ADDENDUM NO. 3

**RE: NCDAC NC Correctional Institution for Women
Air Conditioning Installation
SCO ID#: 22-24913-02A
NCDAC Central Engineering Job Order # 4290**

DATE: September 12, 2023

NOT TO SCALE

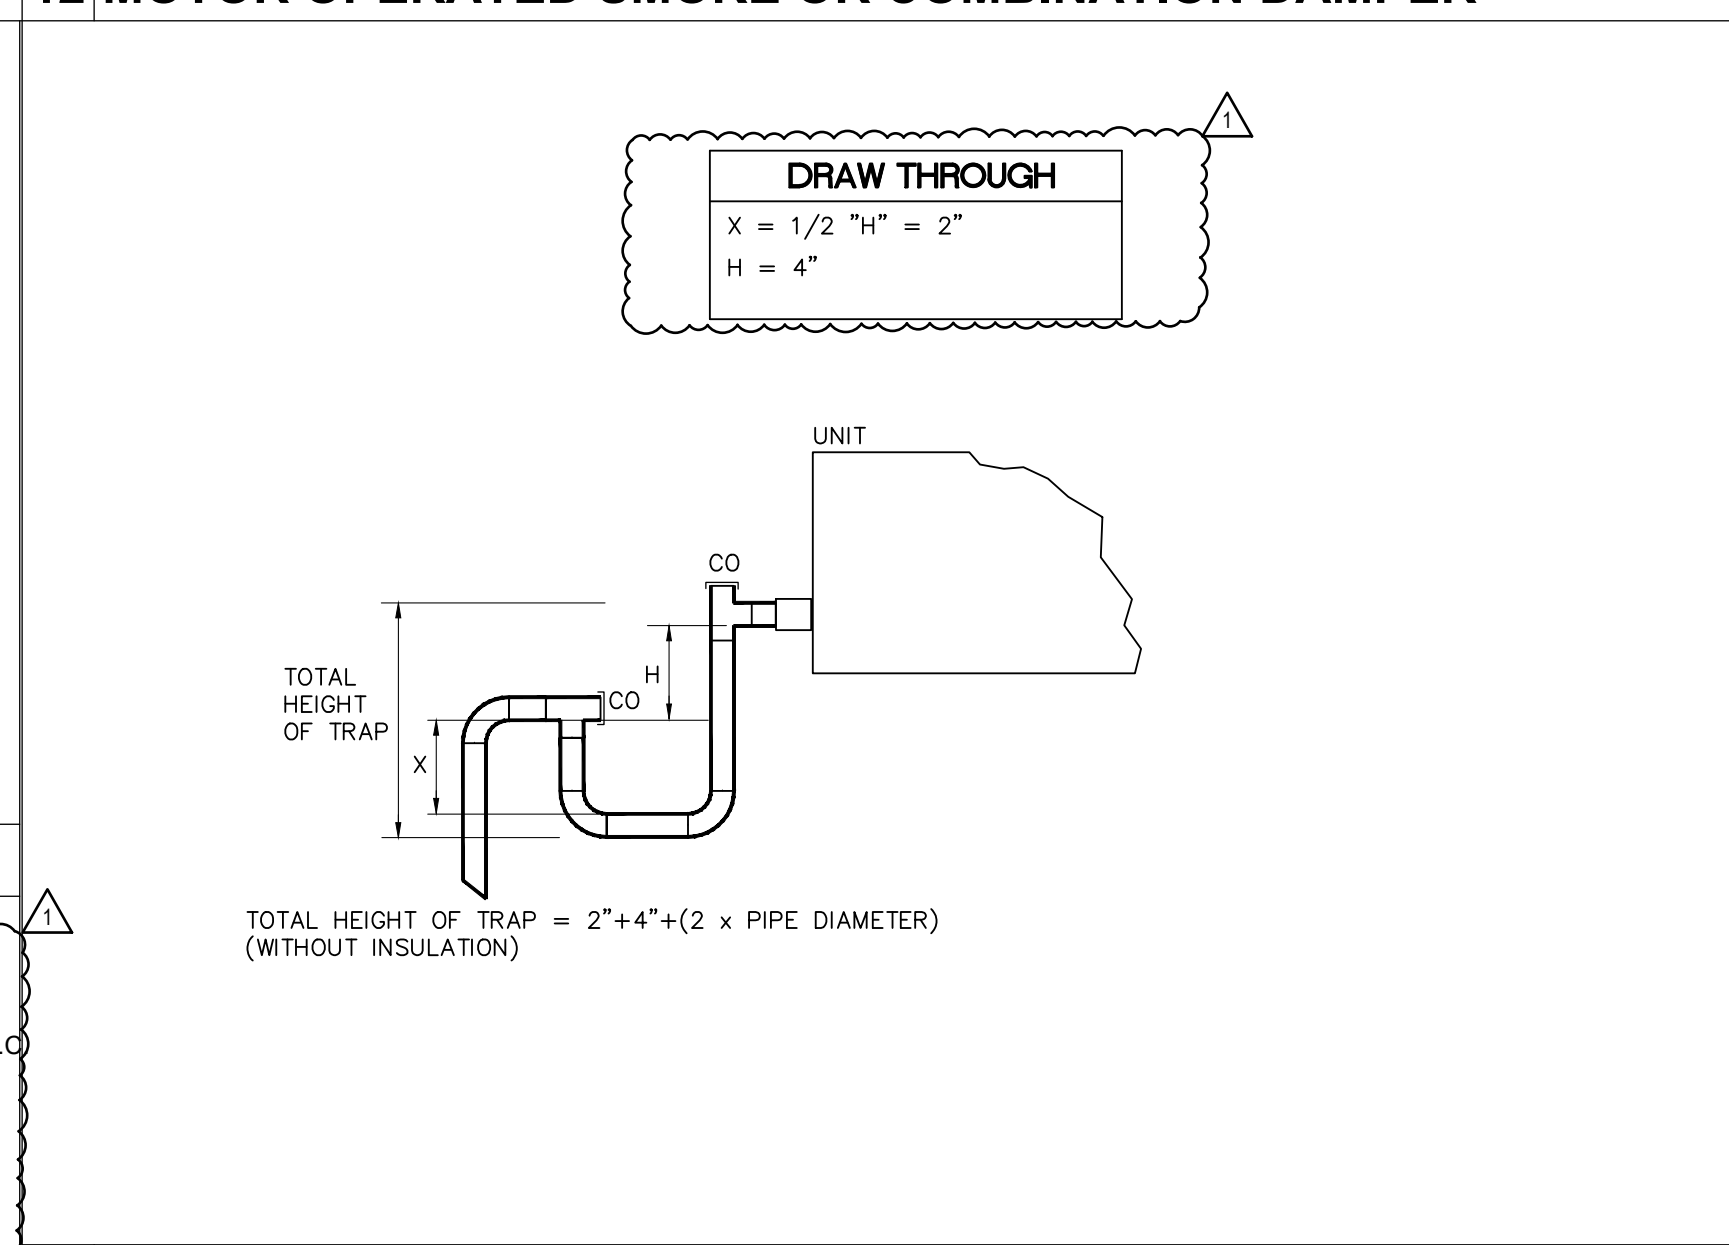
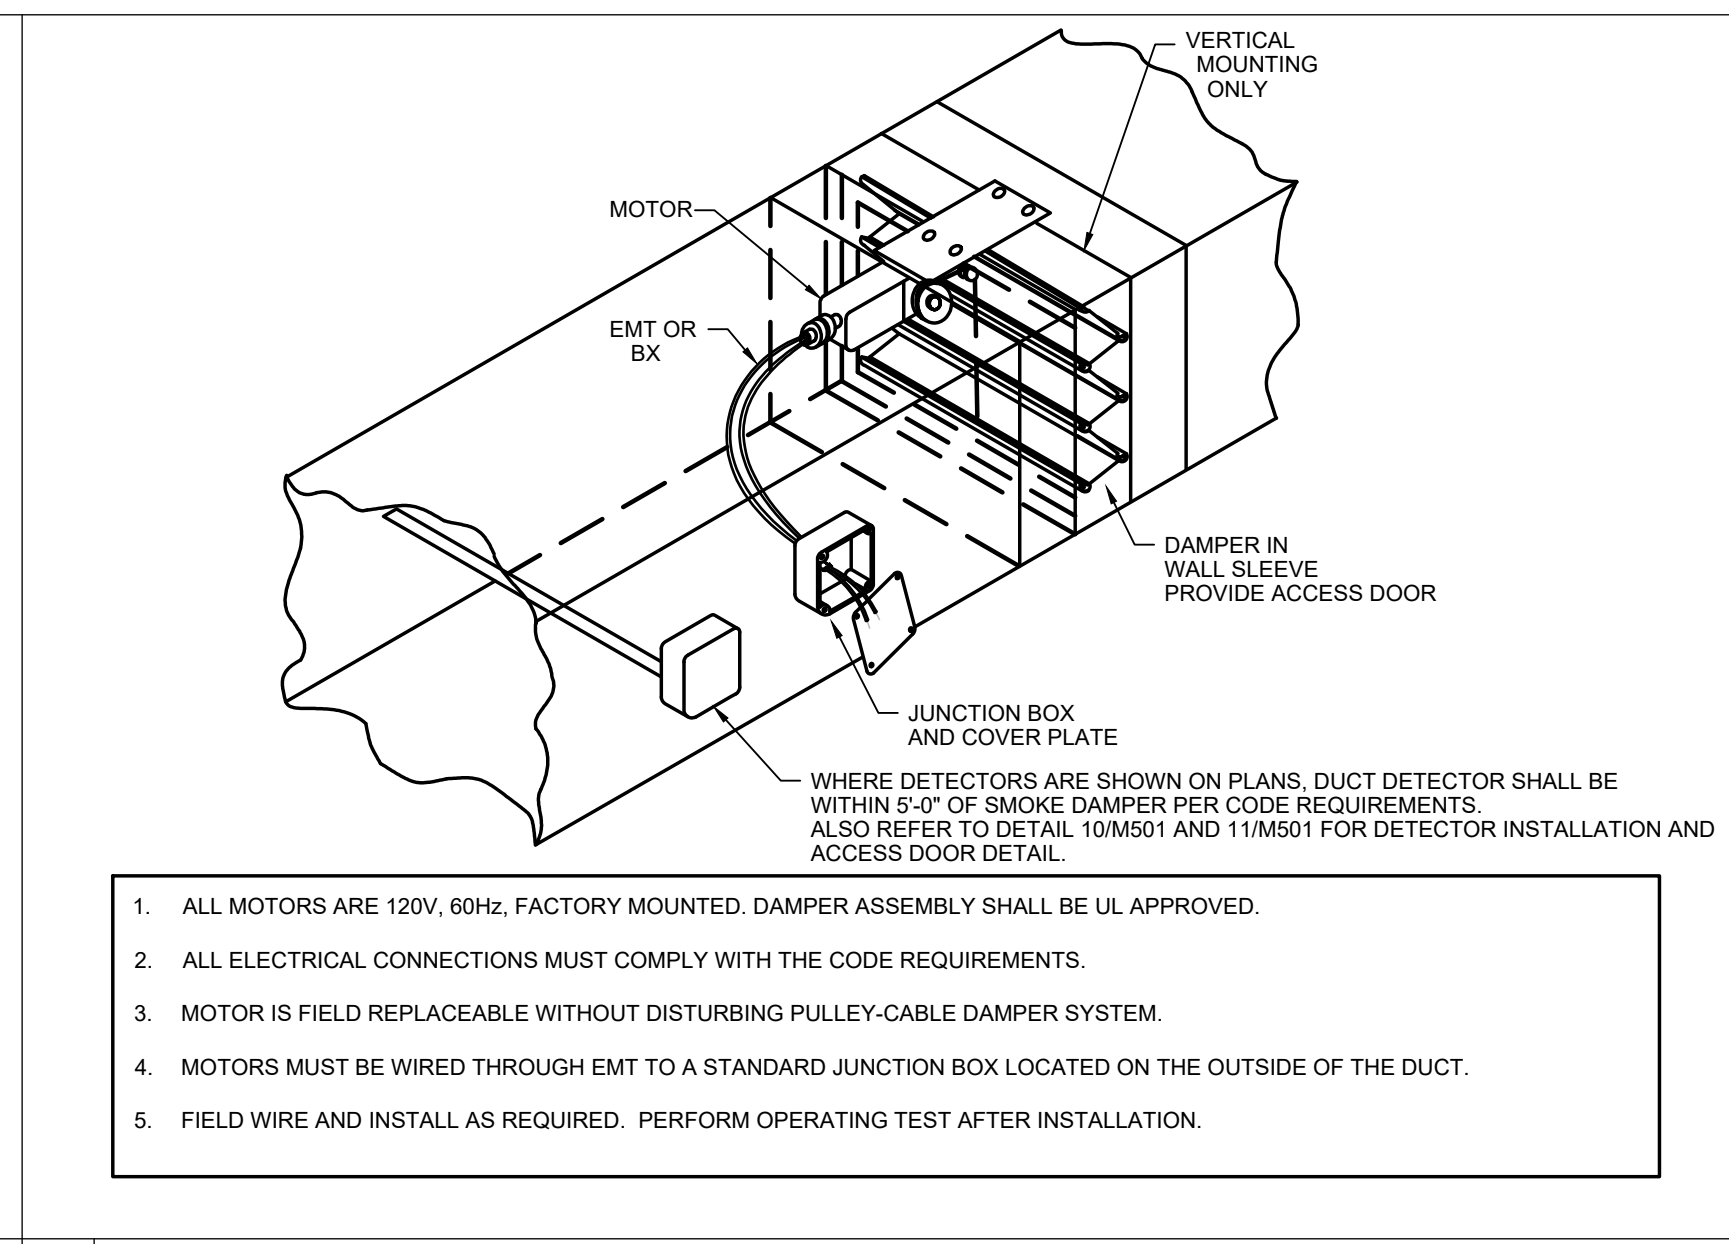
6. Sheet M220: Revised keyed note 1. See revision on attached sheet.
7. Sheet M401: Revised keyed note 6. See revisions on attached sheet.
8. Sheet M501: Revised ductwork detail. Exposed ductwork in dormitories shall be double wall insulated ductwork. See revision on attached sheet.
